Service Bulletin

Machinery Affected: *Auto-Omni™ Saw*
Document: SB200
Title: Upgrading the Hold-Down
Applies To: All with previous hold-down style
Distribution: Upon Order

Item # and Rev.	SB200 rev. A
Date Created	year 2000
Created By	TKC
Revision Date	26 April 2013
Revised By	R. Tucker
Approved By	M. Kanjee
Applicability	All

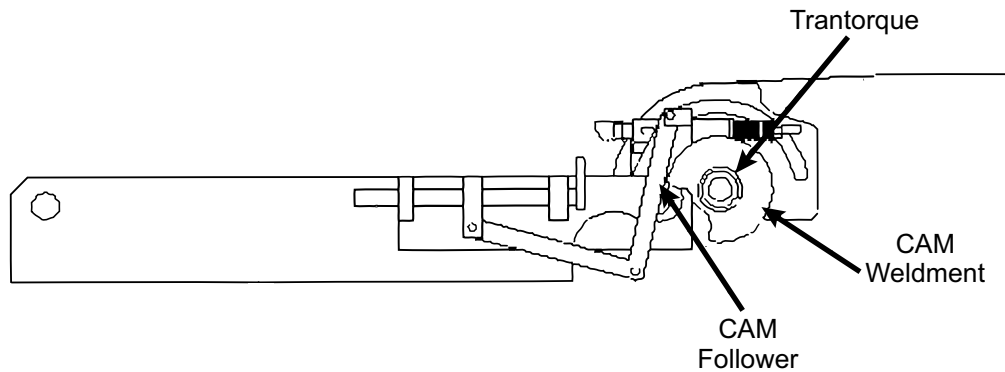
1. Loosen the trantorque (nut breaks twice). Remove cam weldment.

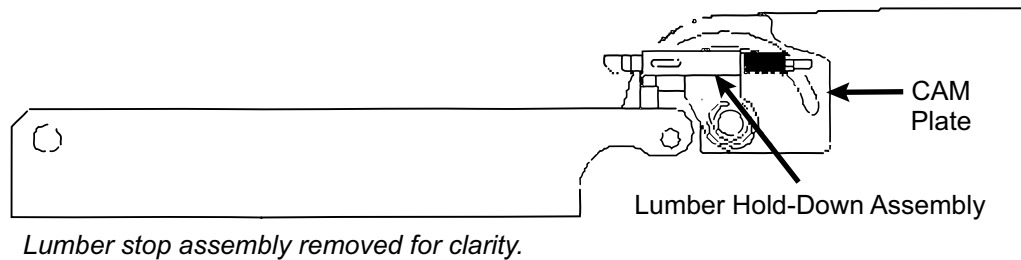
2. Remove lumber hold-down assembly and cam plate.

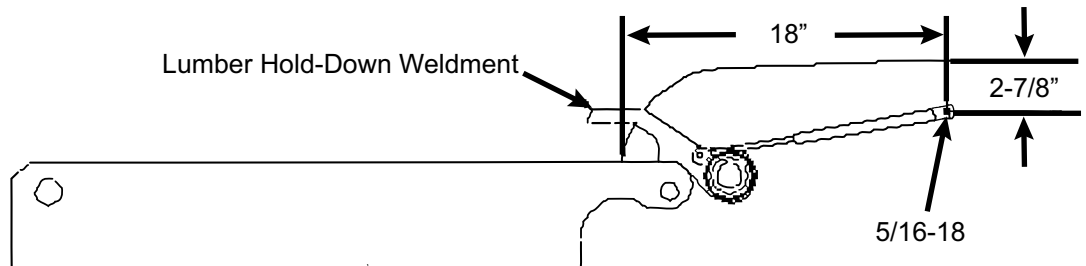
3. Drill and tap as shown using a size F drill bit. Screw in ball stud. Slide on lumber hold-down weldment and snap on gas spring end to ball stud.
